**Project Address:** 6906 Colony Drive  
**Application Type:** Conditional Use and Certified Survey Map Referral  
**Legistar File ID #** [44175](#) and [44186](#)  
**Prepared By:** Timothy M. Parks, Planning Division  
 Report includes comments from other City agencies, as noted.

**Requested Actions:** Approval of a Certified Survey Map (CSM) to create one lot for an existing place of worship at 6906 Colony Drive and one lot for a proposed daycare center, and approval of conditional uses to allow construction of the daycare center.

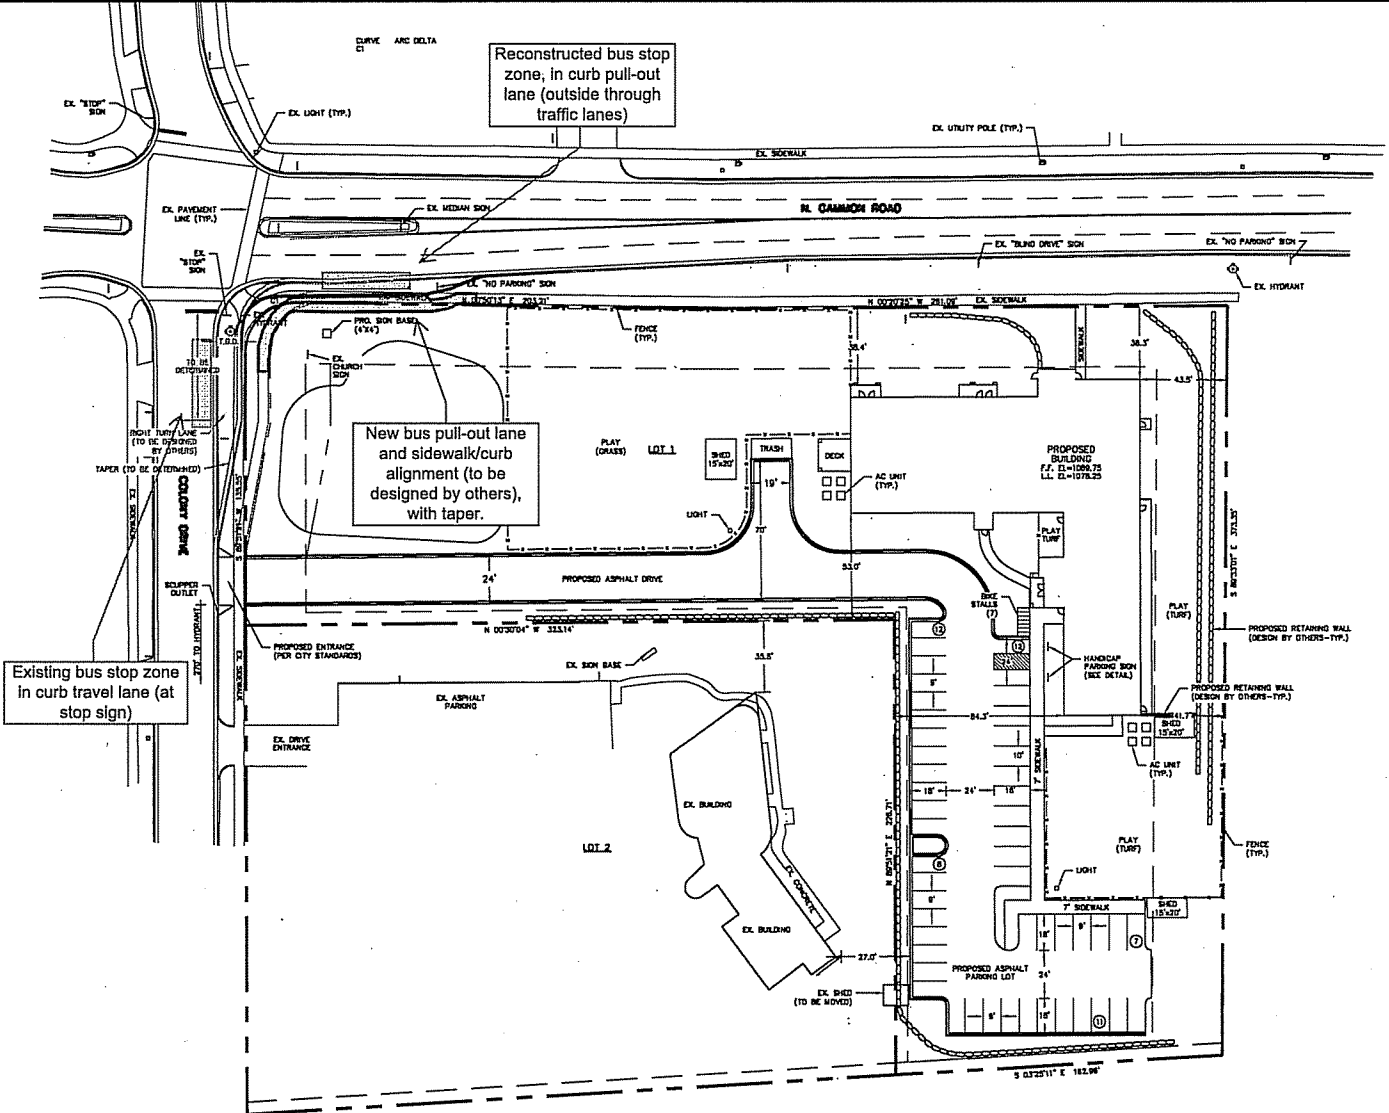
43. The applicant shall dedicate, construct and/or otherwise coordinate with the City of Madison to create a new bus stop zone on the east side of N. Gammon Road, north of Colony Drive as part of any planned changes to the existing intersection's geometry or traffic control (i.e. installation of an added turn lane, or traffic signalization).

44. Metro Transit has attached a draft concept of how an open bus bay design might orient at this new bus stop zone [6906cd\_METRO.pdf]. The applicant shall include the location of these transit amenities on the final documents filed with their permit application so that Metro Transit may review and approve the design.
